**RE: Overlook at Oxbow Subdivision
Conceptual Grading & Drainage Plan
Engineer's Stamp Date: No Stamp Date
Hydrology File: F11D022**

Based upon the information provided in your submittal received 10/20/2020, the Conceptual Grading & Drainage Plan **is not** approved for action by the DRB on Site Plan for Subdivision. The following comments need to be addressed for approval of the above referenced project:

CONCEPTUAL GRADING AND DRAINAGE PLAN

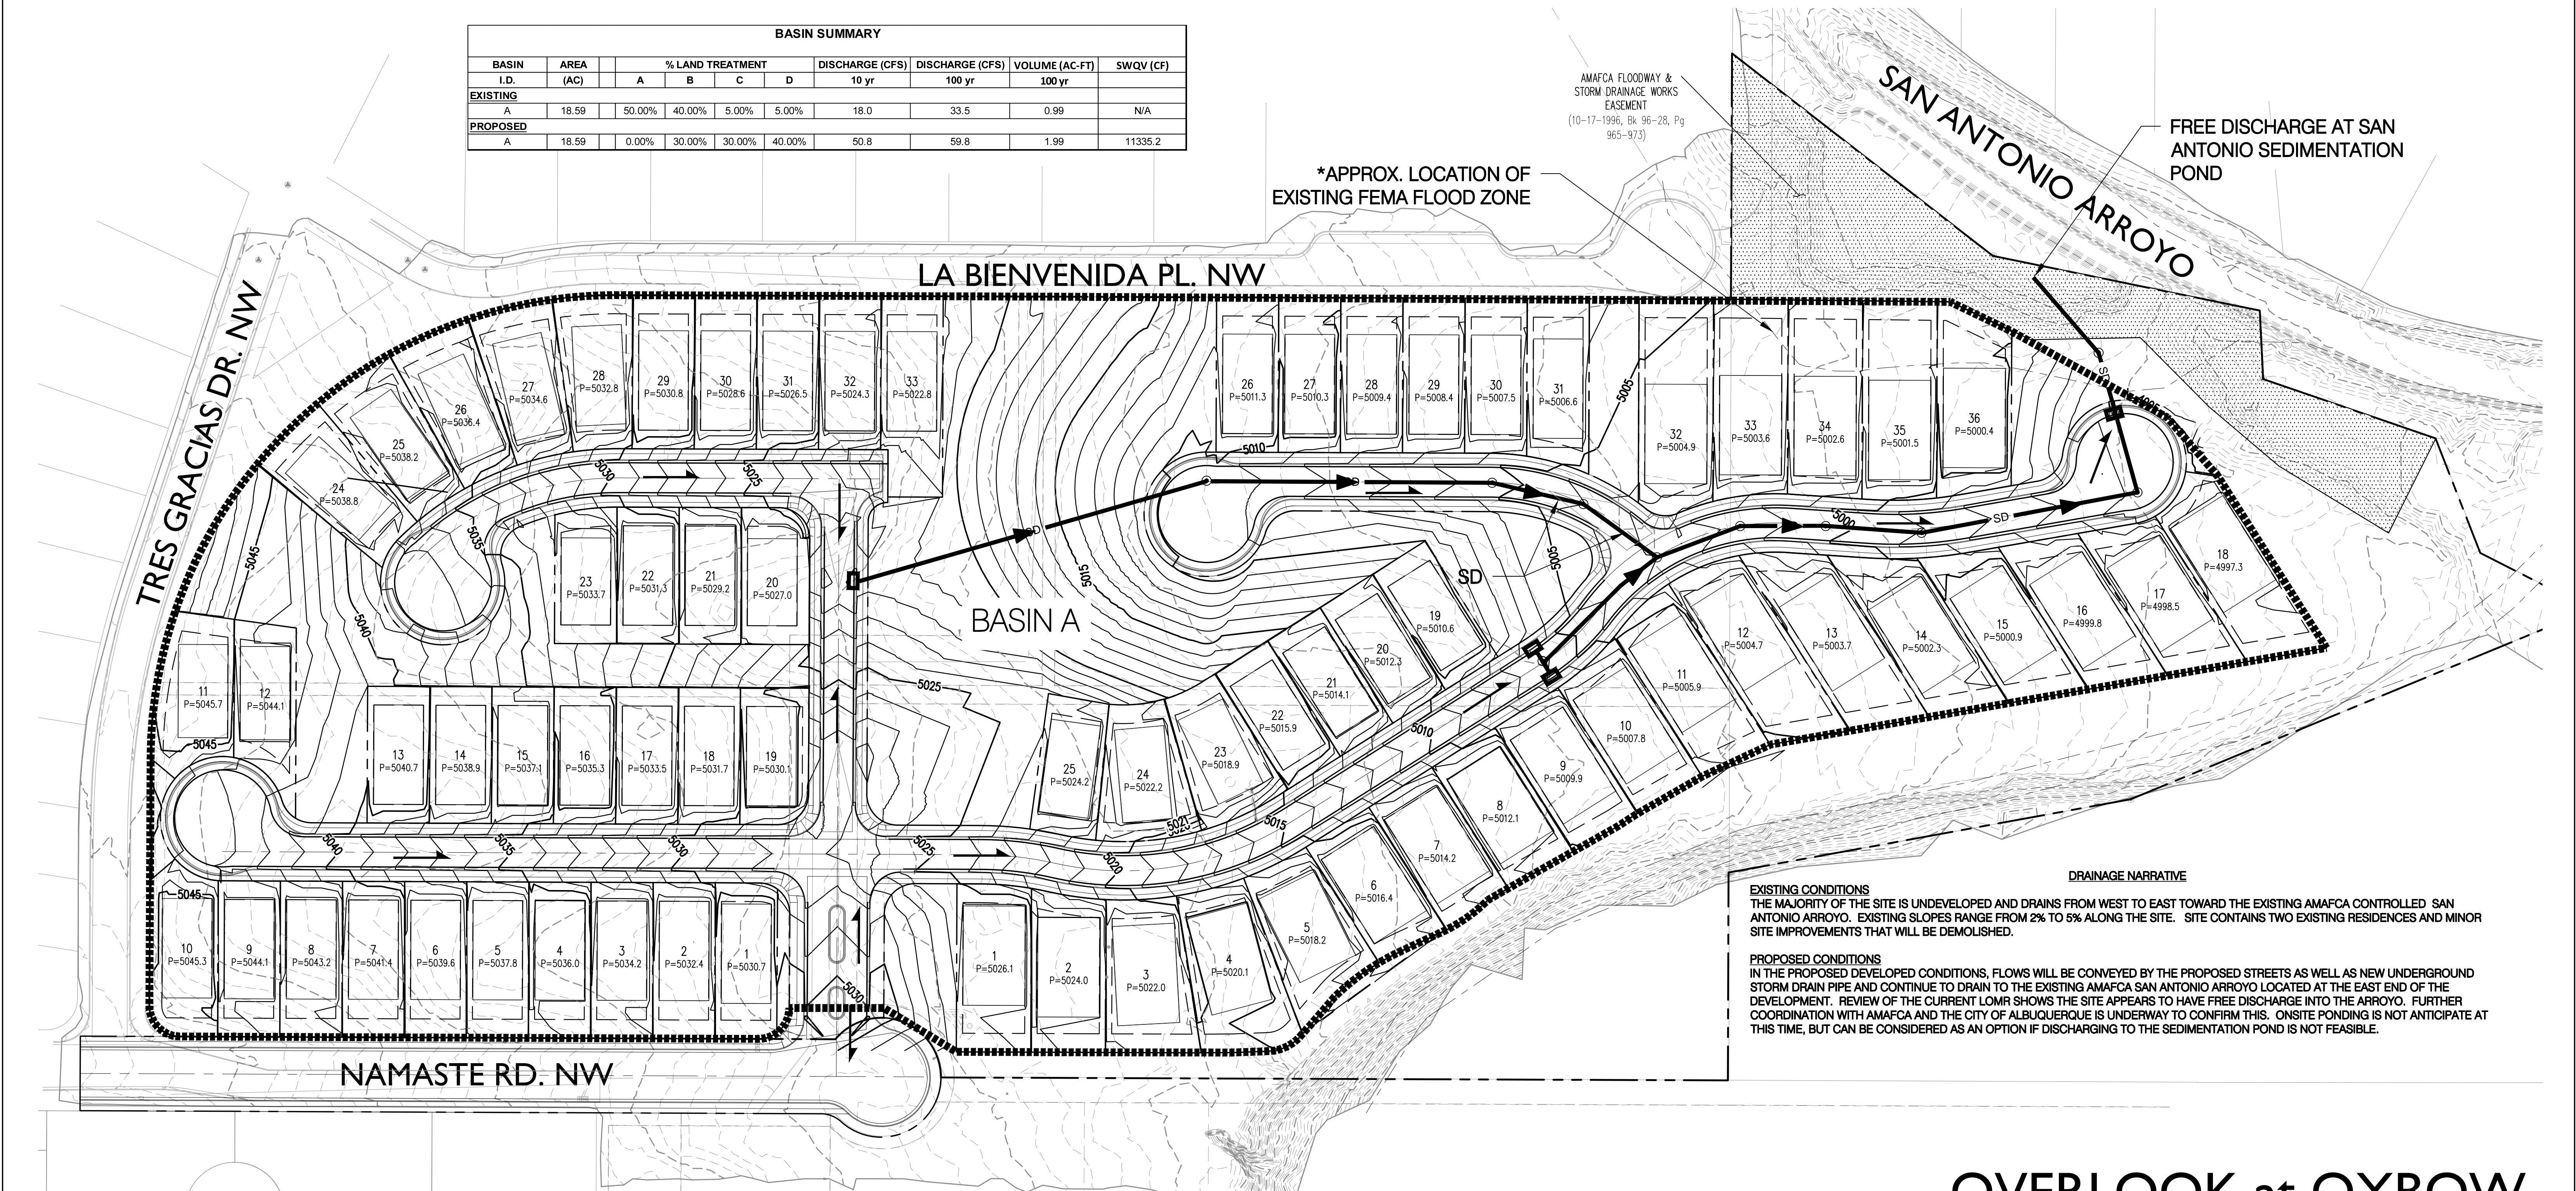
1. Please provide an engineer's stamp with a signature and date on all sheets and drainage report.
2. Since this project ultimately drains into an Albuquerque Metropolitan Arroyo and Flood Control Authority (AMAFCA) facility, approval by AMAFCA will be need prior to Hydrology approval. Please contact Nicole Friedt P.E, CFM (nfriedt@amafca.org or 505-884-2215). An email from Nicole in the Appendix of the Conceptual Drainage Report will be ok.

3. Please provide a conceptual drainage report showing the drainage areas, calculations, storm drain layout with pipe sizes, a section about draining into AMAFA's pond and the capacity of it, and a section talking about the LOMR needed to remove the floodplain on the section of lots within the subdivision.
